ABQ Studios Expansion
MILL 1 & OVERALL SITE

M1S.4
Foundation
FOR PERMIT

DRAWN BY BG
REVIEWED BY CM
DATE 06/13/2022
PROJECT NO. 20-0072.008
DRAWING NAME
LANDSCAPE PLAN

OVERALL LANDSCAPE PLAN

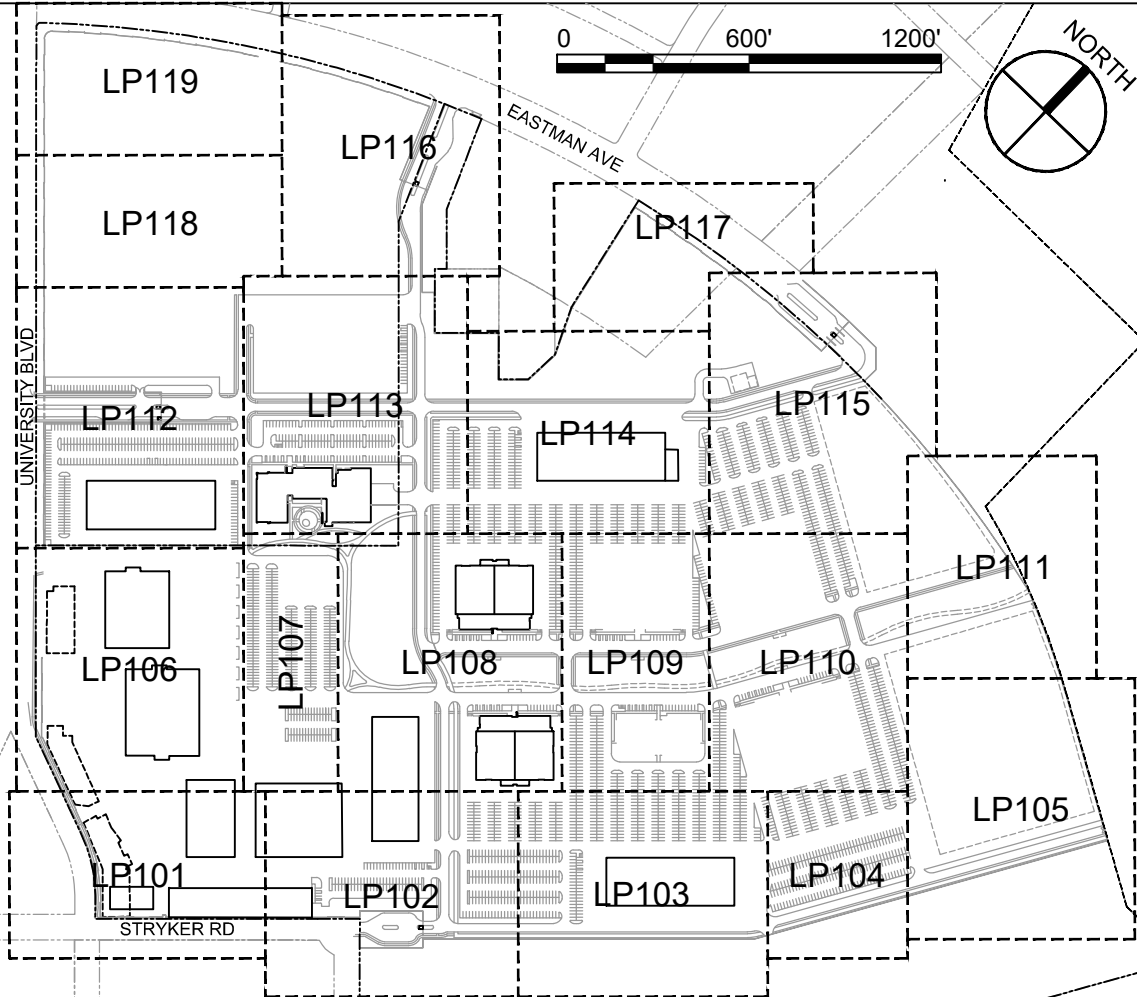
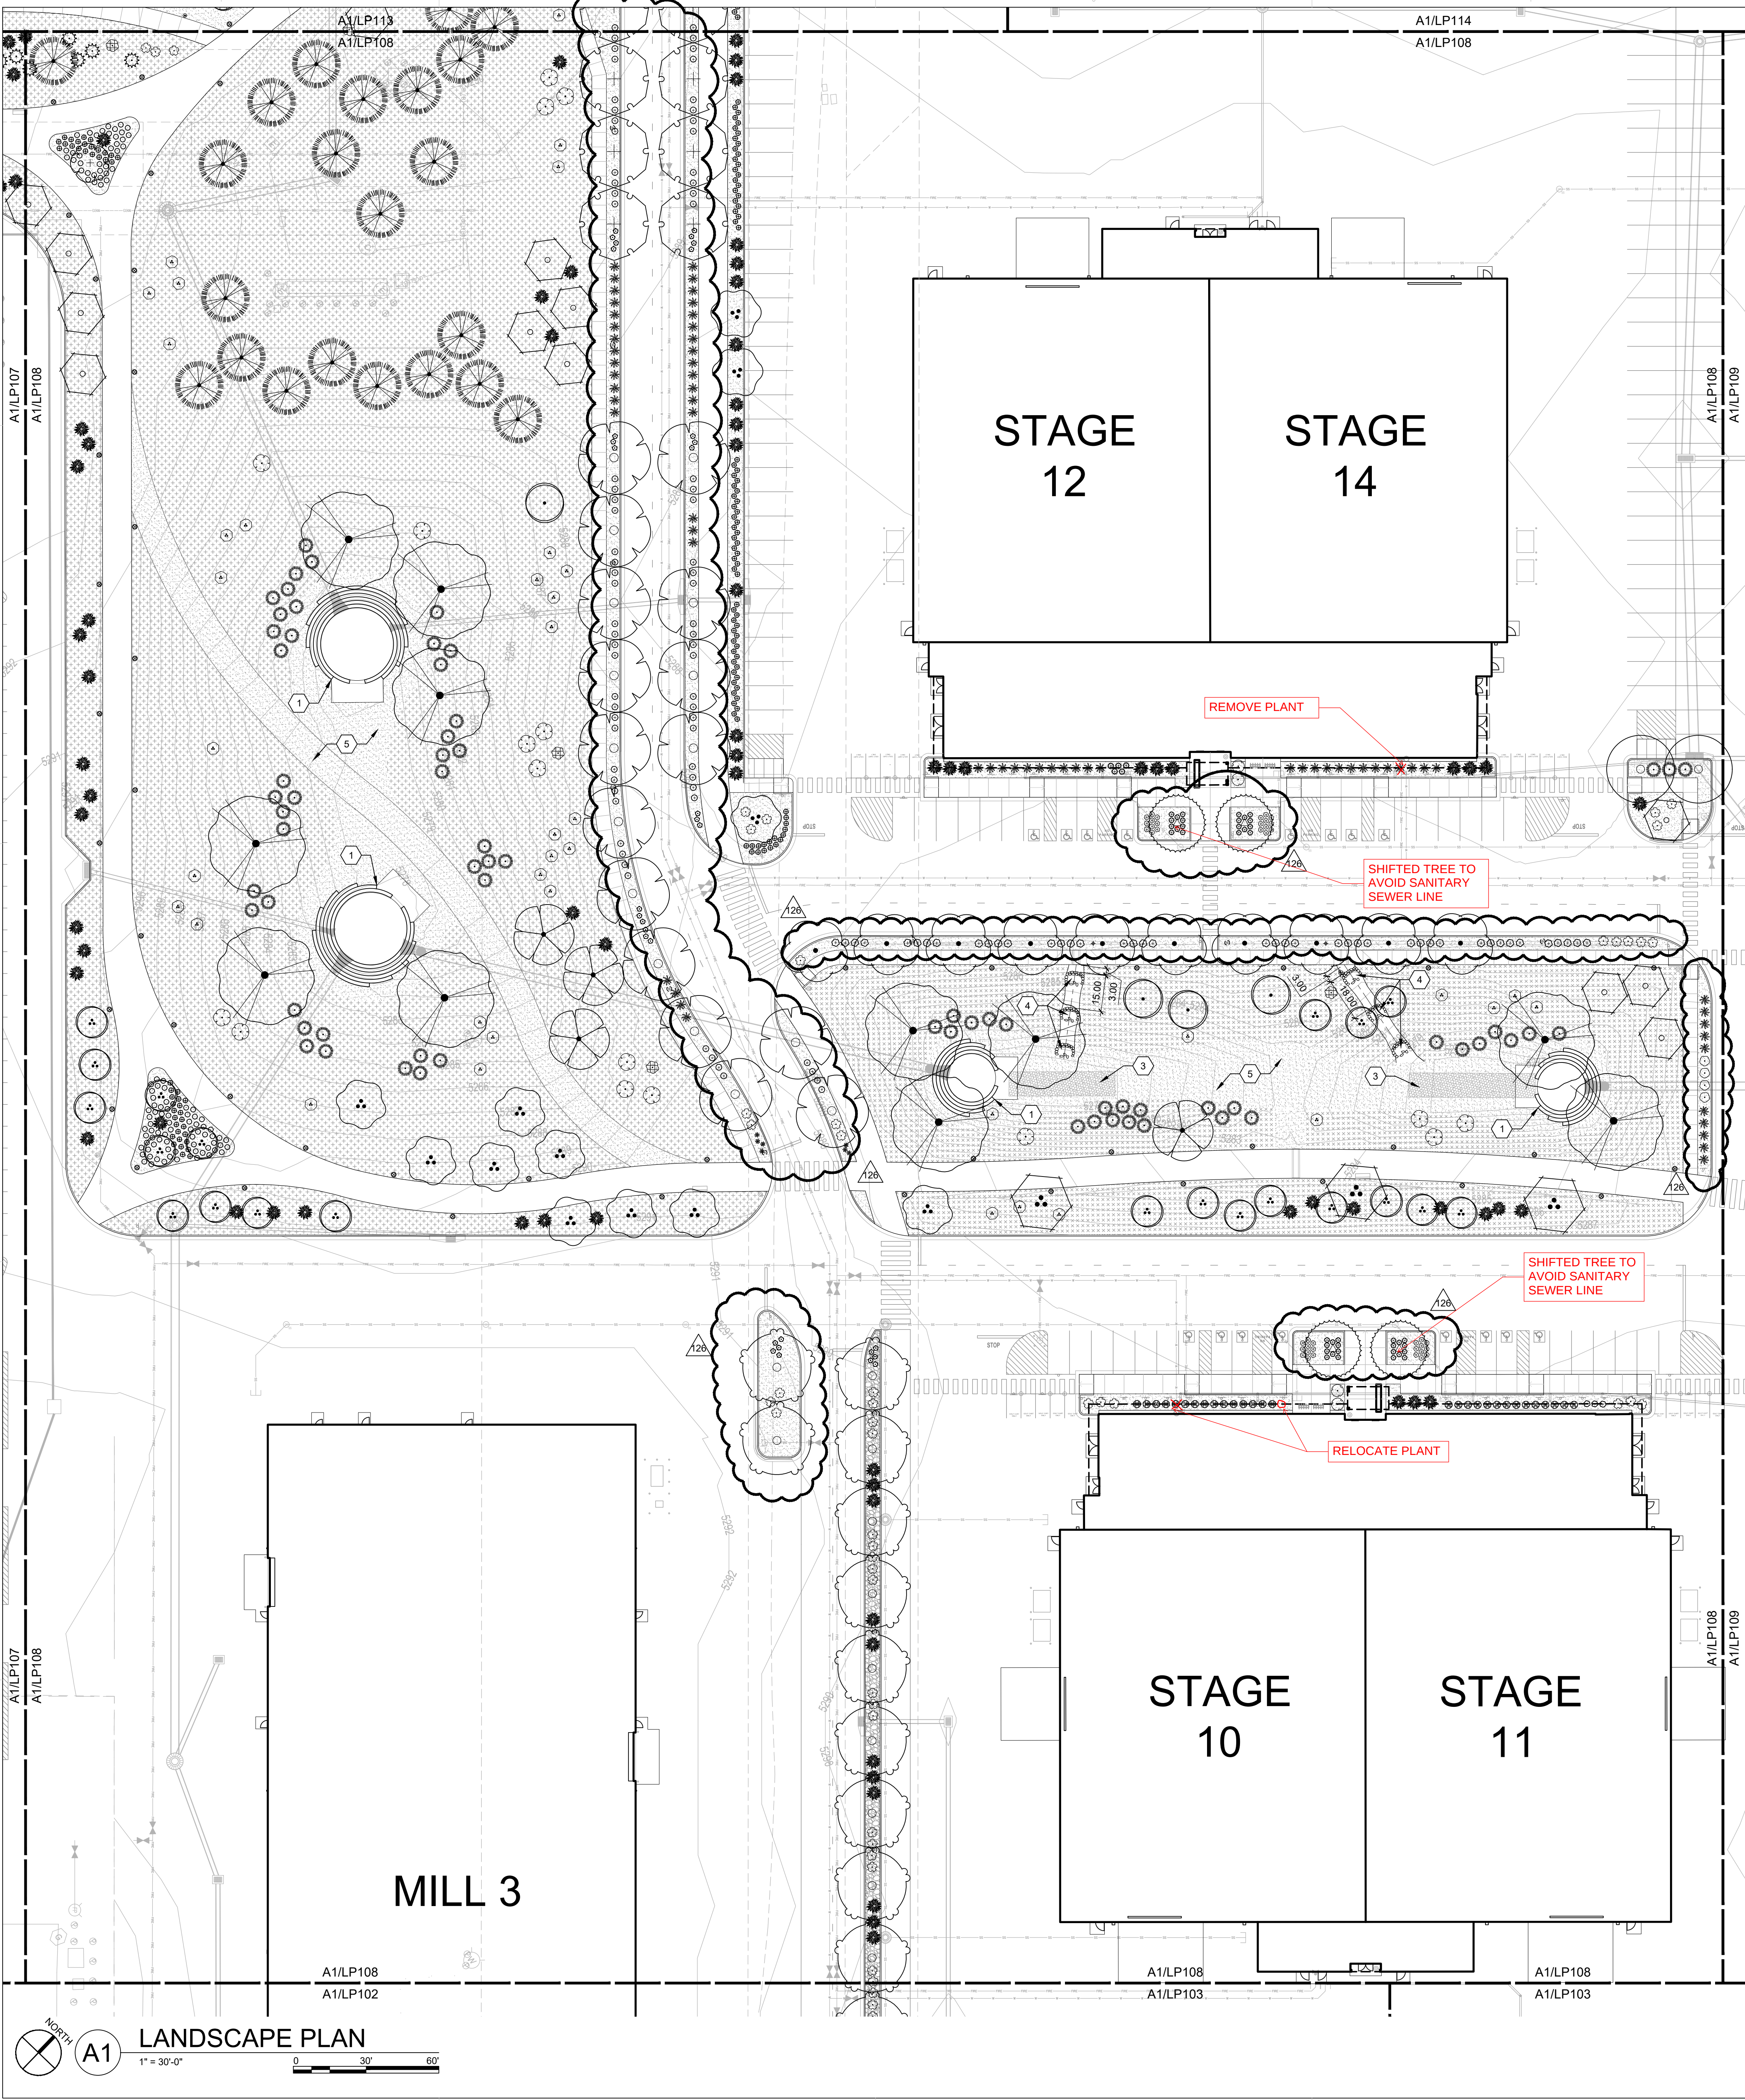
ADD NOTE

U. TREES SHALL NOT BE PLANTED WITHIN 10'-0" IN ANY DIRECTION OF THE CENTERLINE OF A SANITARY SEWER OR WATER LINE.

Shredded wood mulch will be removed from project since after plan consolidation the above requirement is met without using it.
